HISTORIC AND DESIGN REVIEW COMMISSION

December 15, 2021

HDRC CASE NO: 2021-632
ADDRESS: 222 W WOODLAWN AVE
LEGAL DESCRIPTION: NCB 1859 BLK 2 LOT 6 & E 35 FT OF 5
ZONING: R-4, H
CITY COUNCIL DIST.: 1
DISTRICT: Monte Vista Historic District
APPLICANT: GELABERT CHRISTOPHER JAMES & CASSANDRA
OWNER: GELABERT CHRISTOPHER JAMES & CASSANDRA
TYPE OF WORK: Demolition and reconstruction of the rear accessory structure with the construction of a second-story addition
APPLICATION RECEIVED: November 29, 2021
60-DAY REVIEW: Not applicable due to City Council Emergency Orders
CASE MANAGER: Rachel Rettaliata

The applicant is requesting a Certificate of Appropriateness for approval to:

PROPOSED DESIGN

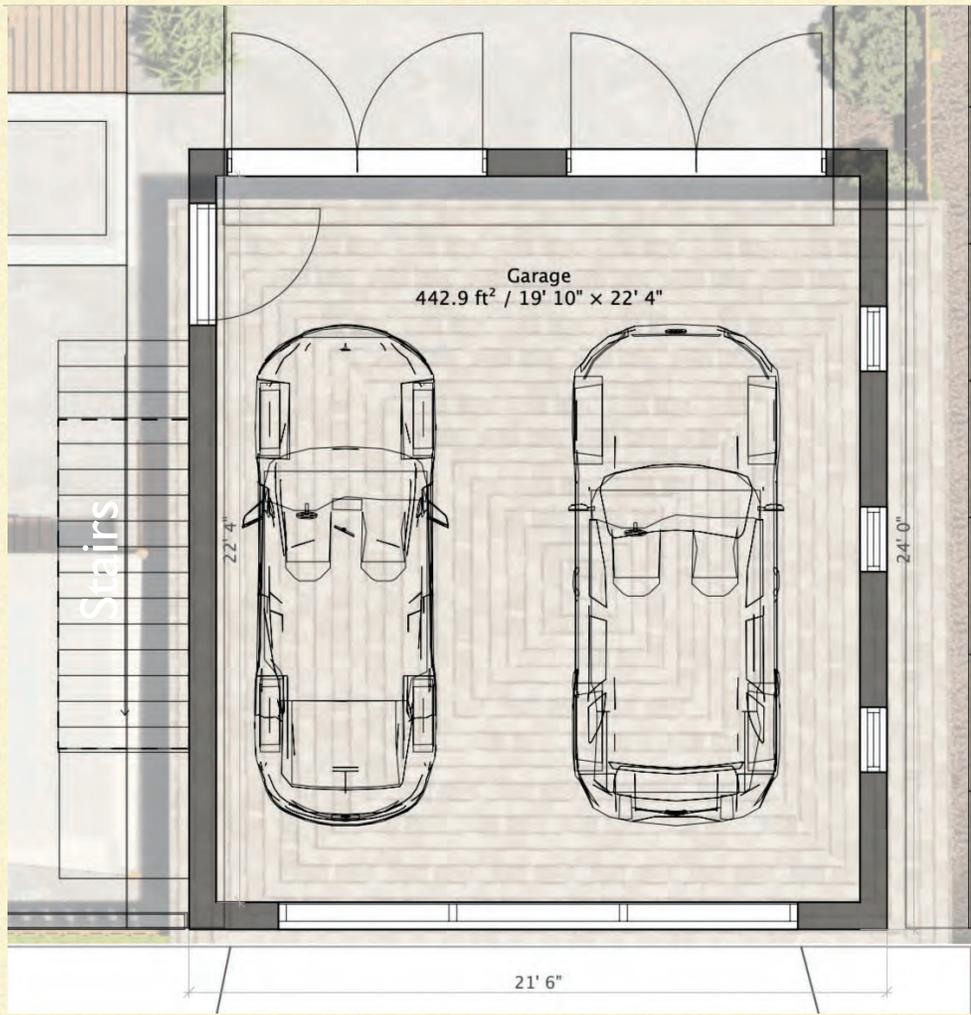
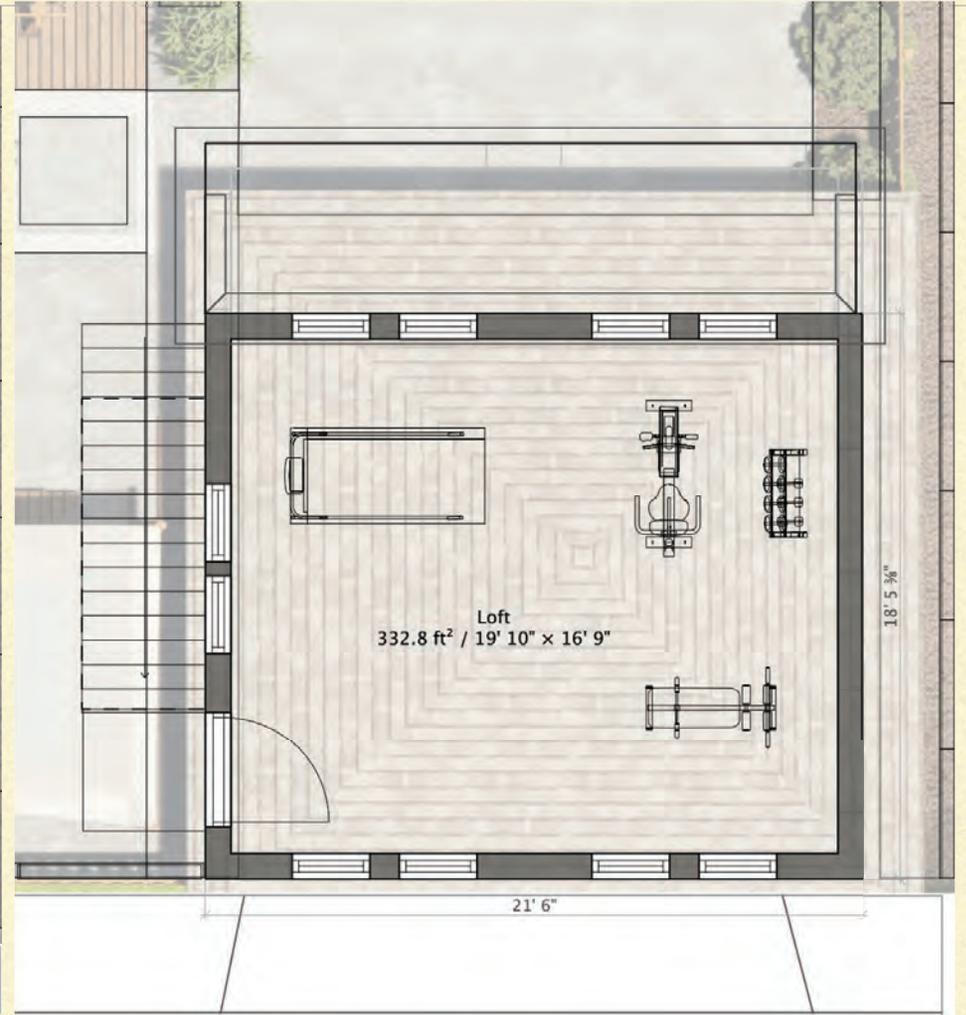
- 2b. **SCALE & MASS** – The applicant has proposed a 2-story garage structure with a hip roof. The top plate height proposed is 18' – 4". The Historic Design Guidelines state that new construction should be consistent with the height and overall scale of nearby historic buildings and rear accessory structures. The scale of the proposed structure does not impact or visually compete with primary structure on the lot or nearby historic structures. Staff finds the proposal consistent with the Guidelines.

- 2d. **ROOF FORM** – The applicant has proposed a hip roof form with a shed roof above the first story. Guideline 2.B.i for New Construction states that new construction should incorporate roof forms – pitch, overhangs, and orientation – that are consistent with those predominantly found on the block. The roof form on the existing rear accessory structure is a pyramidal roof form, the primary structure features a hip roof form with a front gable over the entry, and the existing 2-story rear accessory structure features a hip roof form. Staff finds the proposal appropriate.

- 2e. **MATERIALS** – The applicant has proposed to reconstruct the garage structure using existing wood lap siding salvaged from the existing garage and new wood lap siding to match the existing garage and the primary structure, a red asphalt shingle roof to match the primary structure, two wood carriage doors on the north façade, wood windows to match the windows on the primary structure, and an exterior wood staircase. The applicant has proposed to re-use the existing aluminum garage door on the south elevation and the pedestrian door on the west elevation. The existing structure features wood siding that matches the primary structure, a pressed tin roof, wood carriage doors on the north façade, an aluminum garage door on the south elevation, and a pedestrian door on the west elevation. Staff finds the proposed materials appropriate.

- 2f. **MATERIALS: DOORS AND WINDOWS** – The applicant has proposed to install fully wood divided lite windows. The fully wood windows should feature an inset of two (2) inches within facades and should feature profiles that are found historically within the immediate vicinity. An alternative window material may be proposed, provided that the window features meeting rails that are no taller than 1.25" and stiles no wider than 2.25". White manufacturer's color is not allowed, and color selection must be presented to staff. There should be a minimum of two inches in depth between the front face of the window trim and the front face of the top window sash. This must be accomplished by recessing the window sufficiently within the opening or with the installation of additional window trim to add thickness. Window trim must feature traditional dimensions and an architecturally appropriate sill detail. Window track components must be painted to match the window trim or be concealed by a wood window screen set within the

- 2g. RELATIONSHIP OF SOLIDS TO VOIDS – Guideline 2.C.i for New Construction stipulates that new construction should incorporate window and door openings with a similar proportion of wall to window space as typical with nearby historic facades. Windows, doors, porches, entryways, dormers, bays, and pediments shall be considered similar if they are no larger than 25% in size and vary no more than 10% in height to width ratio from adjacent historic facades. Guideline 5.A.iv for New Construction states that window and door openings should be designed to be similar to those found on historic garages or outbuildings in the district or on the principle historic structure in terms of their spacing and proportions. The applicant has submitted renderings of the reconstructed rear accessory structure that feature windows with traditional window proportions. Staff finds the fenestration pattern consistent with the Guidelines.

Item 2, staff recommends approval of the reconstruction of the rear accessory structure with the construction of a second-story addition based on findings 2a through 2h with the following stipulations:

- i. That the applicant installs fully wood garage doors or garage doors with a design that mimics wood construction and features a smooth finish without a faux wood grain texture. Final garage door specifications must be submitted to staff for review and approval prior to the issuance of a Certificate of Appropriateness.

- ii. That the applicant installs windows that meets staff's standard window specifications and submits final window specifications to staff for review and approval prior to the issuance of a Certificate of Appropriateness. Wood windows should feature an inset of two (2) inches within facades and should feature profiles that are found historically within the immediate vicinity. Meeting rails must be no taller than 1.25" and stiles no wider than 2.25". White manufacturer's color is not allowed, and color selection must be presented to staff. There should be a minimum of two inches in depth between the front face of the window trim and the front face of the top window sash. This must be accomplished by recessing the window sufficiently within the opening or with the installation of additional window trim to add thickness. Window trim must feature traditional dimensions and architecturally appropriate sill detail. Window track components must be painted to match the window trim or concealed by a wood window screen set within the opening. Faux divided lites are not permitted.
